Access Compliance Report Public Rights-of-Way (Curb Ramps)

Main Street: ANDAZA_ST Cross Street: APRENDER_ST Location: SW

ADA ID: RPRK211202135755 Ramp Type: Type 1 - Perpendicular Initial Pass/Fail: Fail Overall Compliance: No Severity Score: 2

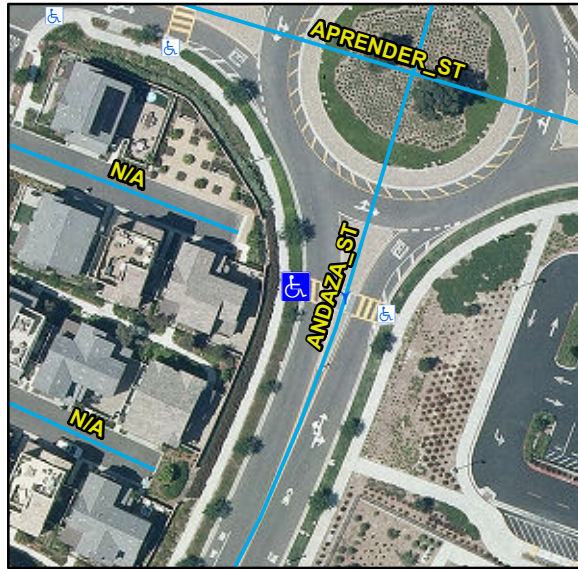
Compliance	Description	Data	Compliance	Description	Data
N/A	Ramp Length (in)	86	N/A	Flare Type LT	
Yes	Ramp Width (in)	60			N/A
Yes	Ramp Run Slope (%)	6.9	N/A	Flare Slope LT (%)	N/A
No	Ramp Cross Slope (%)	3	N/A	Flare Traversable LT	N/A
N/A	Landing Present	N/A	N/A	Flare Type RT	
N/A	Landing Length (in)	N/A			N/A
N/A	Landing Width (in)	N/A	N/A	Flare Slope RT (%)	N/A
N/A	Landing Run Slope (%)	N/A	N/A	Flare Traversable RT	N/A
N/A	Landing Cross Slope (%)	N/A	N/A	DWS Provided	N/A
N/A	Landing Movement Obstructed?	N/A	N/A	DWS Contrast	N/A
	Landing Movement Type	N/A	N/A	DWS Length (in)	N/A
N/A	Landing Shared	N/A	N/A	DWS Full Width	N/A
N/A	Clear Space	N/A	N/A	DWS Offset Left (in)	N/A
N/A	Clear Space To Crosswalk (in)	N/A	N/A	DWS Offset Right (in)	N/A
N/A	Marked Crosswalk 1	Yes	N/A	Marked Crosswalk 2	N/A
	Crossing 1 Direction	E		Crossing 2 Direction	N/A
	Marked Crosswalk 1 Width (in)	144		Marked Crosswalk 2 Width (in)	N/A

N/A	Ramp Inside Crosswalk 1	Yes	Yes	Ramp Inside Crosswalk 2	N/A
	Crossing 1 Slope (%)	2.6		Crossing 2 Slope (%)	N/A
	Crossing 1 Cross Slope (%)	1		Crossing 2 Cross Slope (%)	N/A
N/A	Gutter Ponding	N/A	No	Curb Slope	7
Yes	Gutter Lip Height (in)	0		Road Run Slope (%)	N/A
N/A	Gutter Run Slope (%)	N/A		Road Cross Slope (%)	N/A
N/A	Gutter Cross Slope (%)	N/A			
Yes	Overall Surface Condition: Acceptable		Yes	Perp Joint Present	Yes
	Cross Gutter Present?	No		Spandrel Present?	No
	Replace Cross Gutter?	N/A		Replace Spandrel?	N/A

Remove & Replace Entire Ramp.
